PLANNING COMMISSION RESOLUTION NO. 89-08

A RESOLUTION OF THE CITY OF MILL)
CREEK PLANNING COMMISSION,)
RECOMMENDING APPROVAL TO THE)
CITY COUNCIL OF THE CITY OF MILL) FINDINGS,
CREEK, WASHINGTON OF A) REASONS AND
PRELIMINARY PLAT FOR HAMLIN PARK,) RECOMMENDATIONS
A EIGHTY ONE (81) LOT RESIDENTIAL)
SUBDIVISION. CASE FILE NUMBER LP 88-)
26.)

EXHIBIT A
DEPARTMENT OF COMMUNITY DEVELOPMENT
STAFF REPORT
TO MILL CREEK PLANNING COMMISSION

NAME OF PROJECT: Hamlin Park

**EXHIBIT B
PRELIMINARY PLAT
HAMLIN PARK
AUGUST 23, 1989**

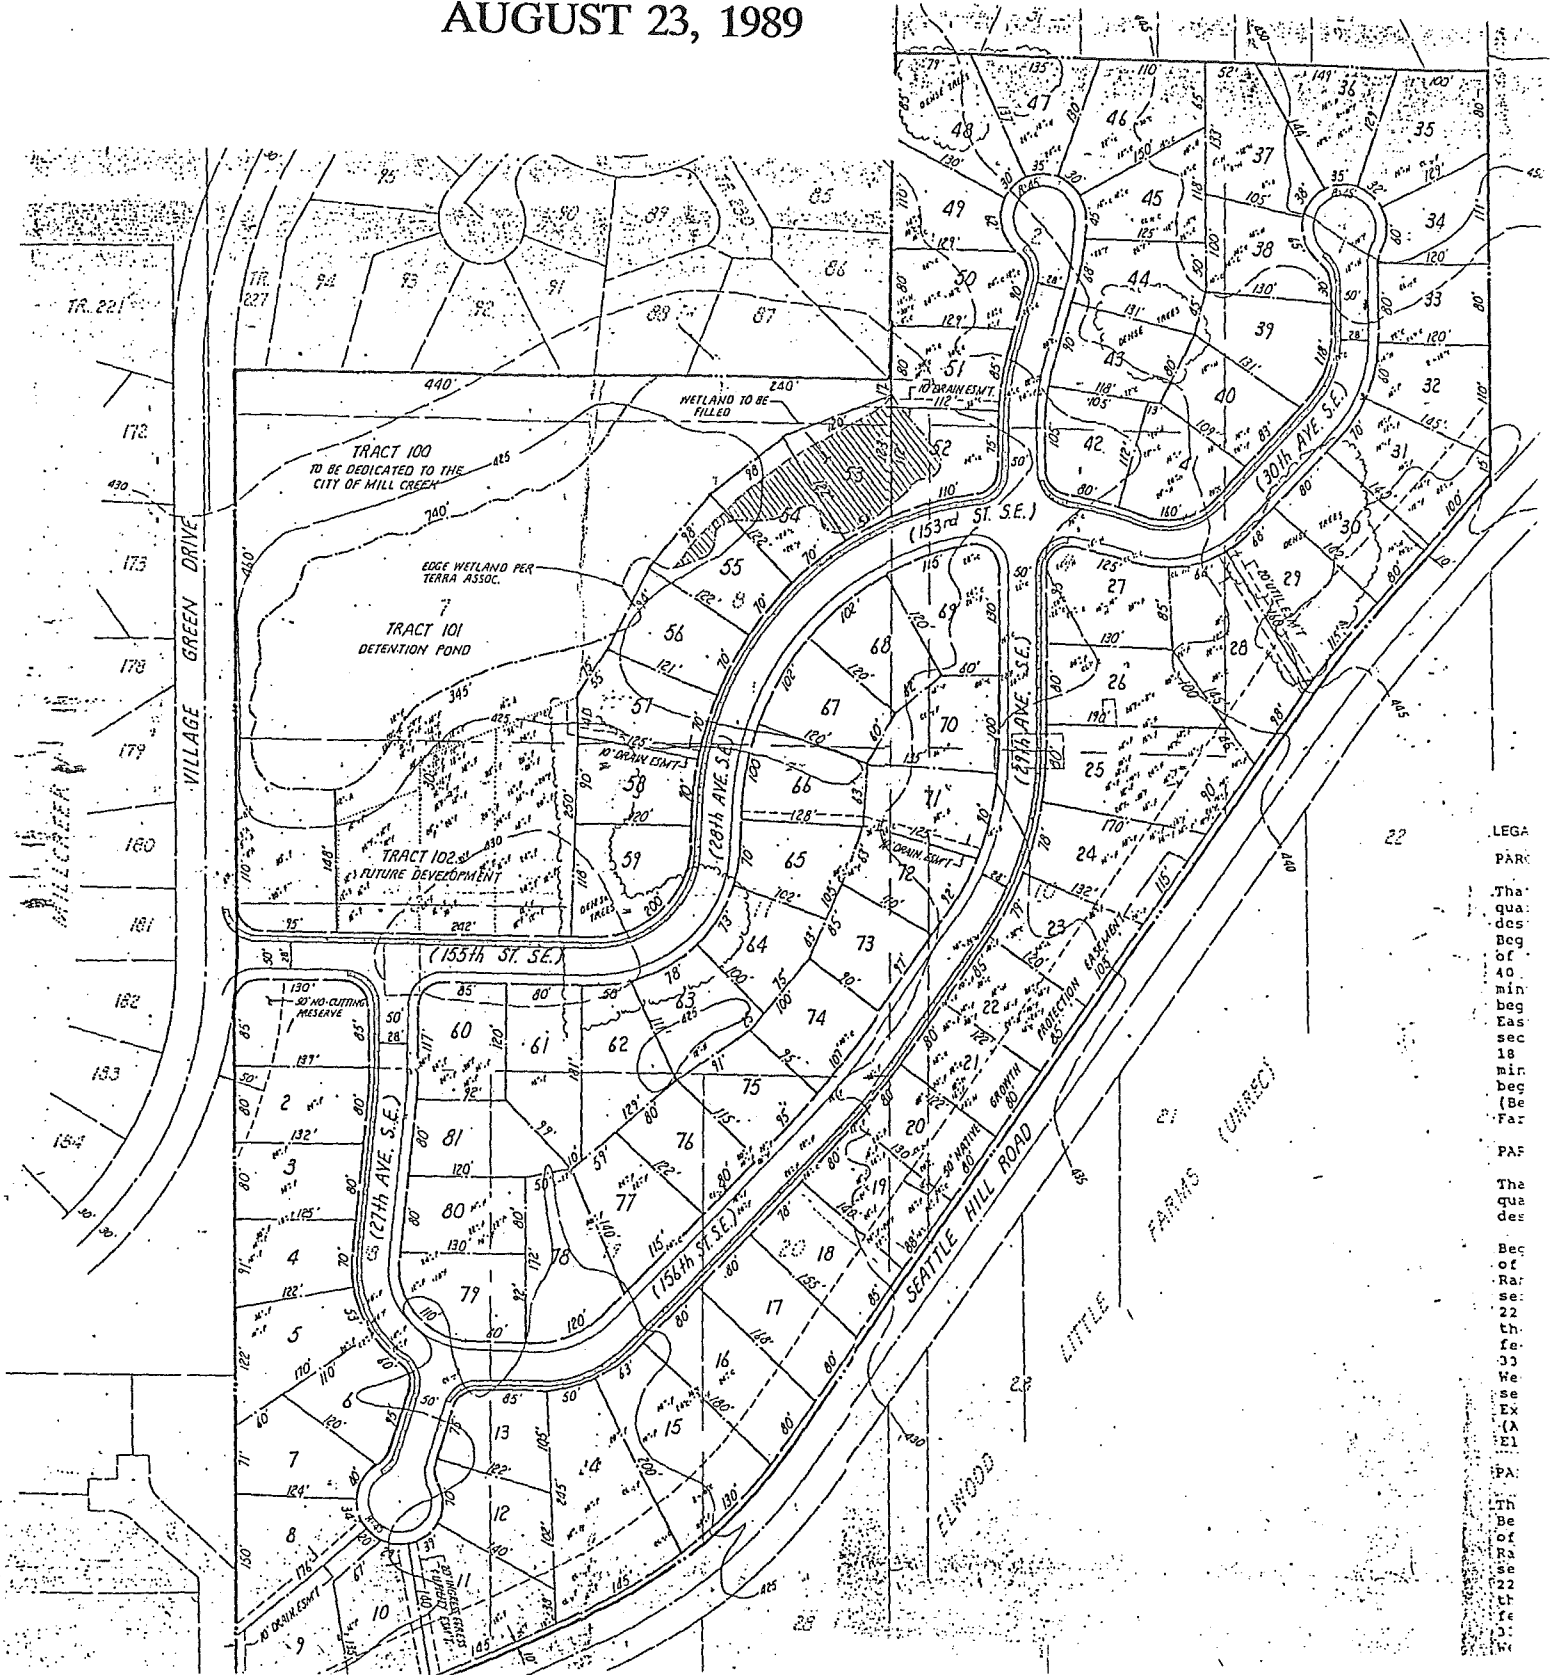
Comment: Nearly all of the lots meet or exceed the requirements of the zoning ordinance. Five lots; 6, 72, 73, 74 & 76 are less than 9600 square feet, the smallest being 8900 square feet. Under the provisions of Section 16.02.060, lot size averaging is permitted with certain limitations. One is that lots cannot be smaller than .75 of the minimum lot size of the zoning district in which the plat is located. In the R 9600 district this would be 7200 square feet. As mentioned previously, the average lot size for this plat is over 11,000 square feet.

MOTION: Commissioner Hornbeck moved to approve LP 88-26 - Hamlin Park as presented based on staff report, findings, recommendations, and conditions with the provision made that the attached plat map presented to the Commission be changed to move the cutting preserve along Seattle Hill Road one (1) foot in from the dedicated right-of-way to the north to permit fencing; also adding the staff recommendation to provide for a left turn lane at the entrance to Village Green Drive, and amending Recommendation No. 12 to read tracts 104 - 105 connect with Seattle Hill Road, with pathways to be located between Lots 18 and 19, and between interior lots 62 and 65, and 75 and 76. Commissioner McElhose seconded the motion.

Review of the preliminary plat map indicates that the applicant has eliminated all lots previously situated within the wetland boundary. While the residential use of the lots in the wetland area has been eliminated, the proposed drainage plan includes a sediment pond to be constructed within the same wetland area previously occupied by the proposed lots.

These tracts, depicted on the attached revised plat map, will provide pedestrian linkage to the Highlands residential neighborhoods. In addition, the applicant has provided an internal pathway system linking the tract from Seattle Hill Road with the internal roadway and sidewalk system within the plat. The width of the internal tract is twenty (20) feet with six (6) foot paved pathways provided within those open space tracts.

1. Development shall occur as portrayed on the revised preliminary plat map dated October 31, 1989, except as it may be modified by the imposition of conditions imposed by the Planning Commission.
2. The maximum number of building lots shall be 81. Construction shall be limited to one single-family detached home per lot.
3. Water and sewer facilities shall be designed and installed in accordance with the requirements of the Alderwood Water and Sewer District.
4. An erosion control plan shall be submitted for approval by the Public Works

9. No structure shall be located within 50 feet of the edge of the wetland. This restriction shall be depicted on the face of the final plat. In addition, the rear 20 feet of lots 54 - 58 shall be replanted with native plantings associated with wetland areas as recommended by the Washington State Department of Ecology.

10. Stormwater shall be managed in accordance with the plans and specifications submitted by Triad Associates dated October 26, 1989 and accepted by the Public Works Director. Further, the proposed pond shall not encroach into any area identified as a forested wetland nor require tree removal.
